Re: 1609 S Park Street, Legistar 78428

Plan Commission
Meeting of August 28, 2013
Agenda #18, Legistar #78428

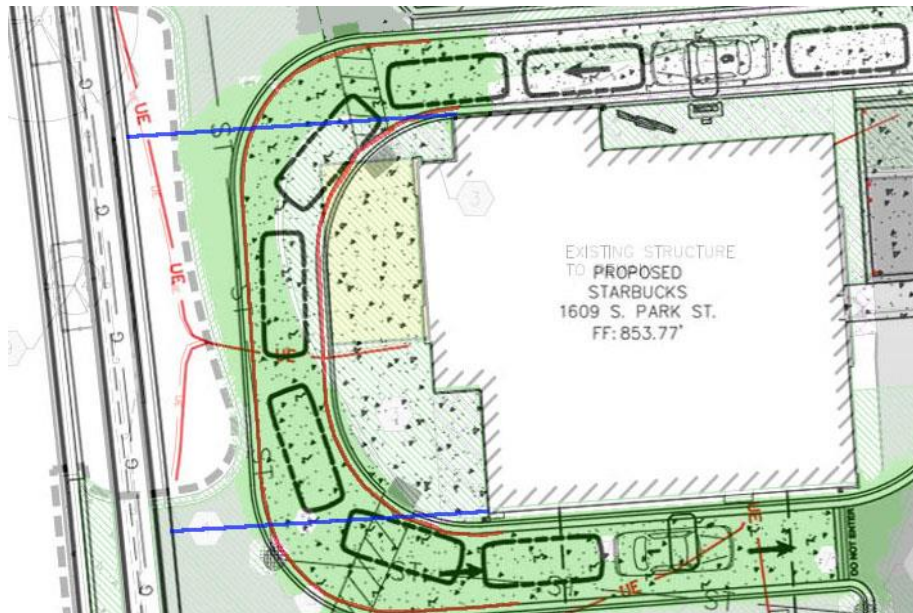
"Per the revised letter of intent dated August 23, 2023 the coffee shop would be a drive-thru only location with no walk-up service. In discussing the change with the applicant they noted that the walk-up service was removed due to potential pedestrian-vehicle conflicts." (Page 3 of the Staff report.)

- Plan Commission is being asked to approve a drive-thru coffee shop, not a coffee shop with a drive-thru.
 - A coffee shop is a permitted use, a drive-thru is an accessory use which requires conditional use approval. An accessory use is a "use on the same lot with, and of a nature *customarily subordinate to, the principal use* or structure, and serving the occupants of the principal use or structure." MGO 28.211 (emphasis added)

- The drive-thru will not be subordinate to the principal use. Rather, the drive-thru will be the principal, and only, use.
- Even though Starbucks will not have walk-up service, the provisions of MGO 28.151 still apply. In particular: "Site design shall accommodate a logical and safe vehicle and pedestrian circulation pattern."

- The area between the building and the street is being substantially altered. Below are images of Sheet C201 (site plan) overlaid on Sheet C101 (demolition plan). With this amount of change, it is hard to argue that the nonconforming use is being continued.

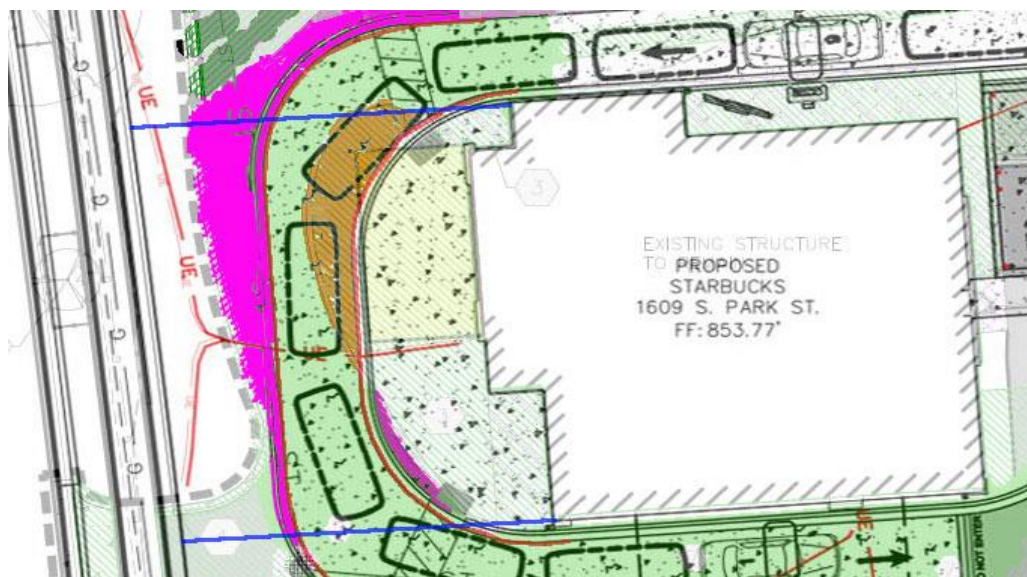
The light green background is the current drive.
The red lines are the new vehicle access sales and service drive

Fuchsia is the portion of the current drive that will not become part of the new vehicle access sales and service drive.
Rust is the area which is not part of the existing drive but which will become part of the new vehicle access sales and service drive.
